Concurrency issues in the PSE state diagram (D3.1) v100

145.2.5.7 State diagrams

Figure 145-15—Primary Alternative dual-signature semi-independent PSE state diagram

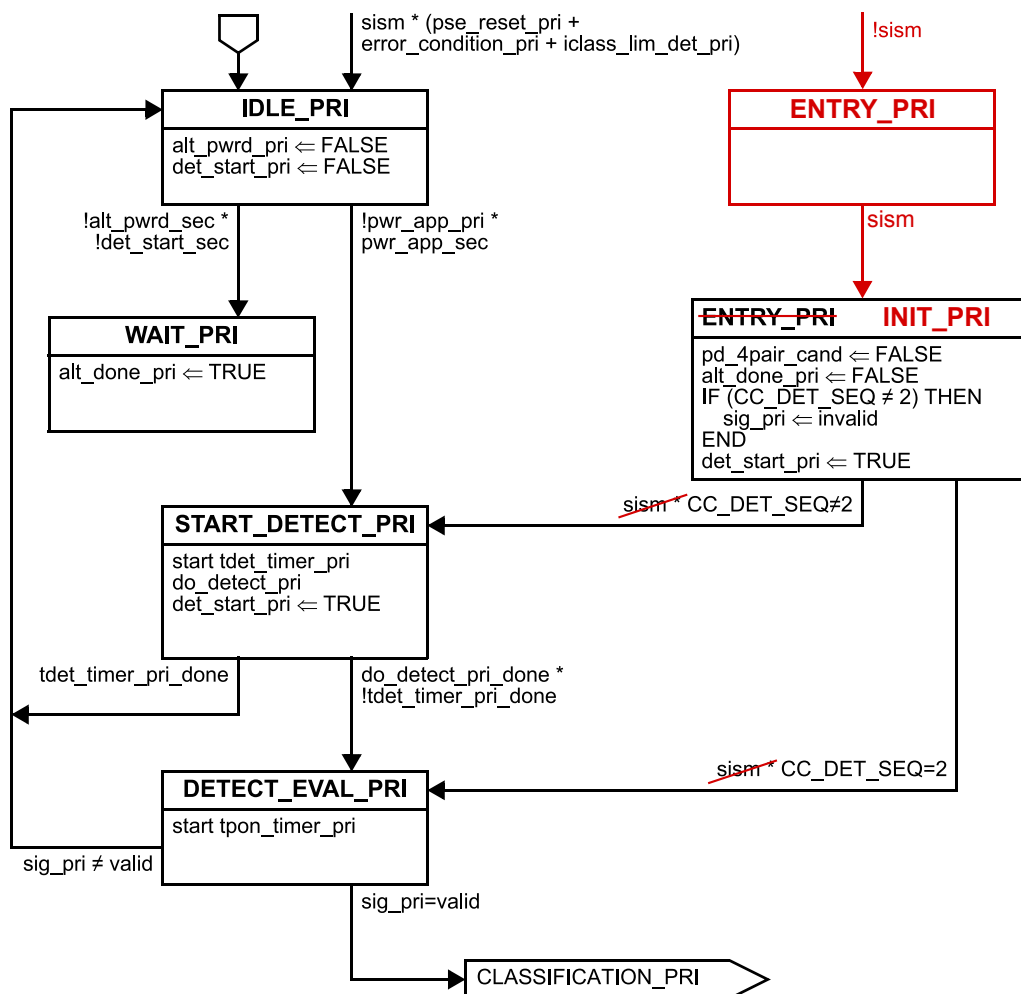
As one can imagine, there is some risk of concurrency issues, given that all of these state machines operate on the same variable space. Specifically, the variables assigned in the ENTRY_PRI and ENTRY_SEC state clobber results in the top level state machine. To resolve this, a new (assignment free) state is introduced before ENTRY_PRI (which is renamed to INIT_PRI).

At least the variables pd_4pair_cand and sig_pri are overwritten continuously by the SISM state diagrams when sism=FALSE. This interferes with detection in the top level state diagram.

Change Figures in 145.2.5.7 as follows:
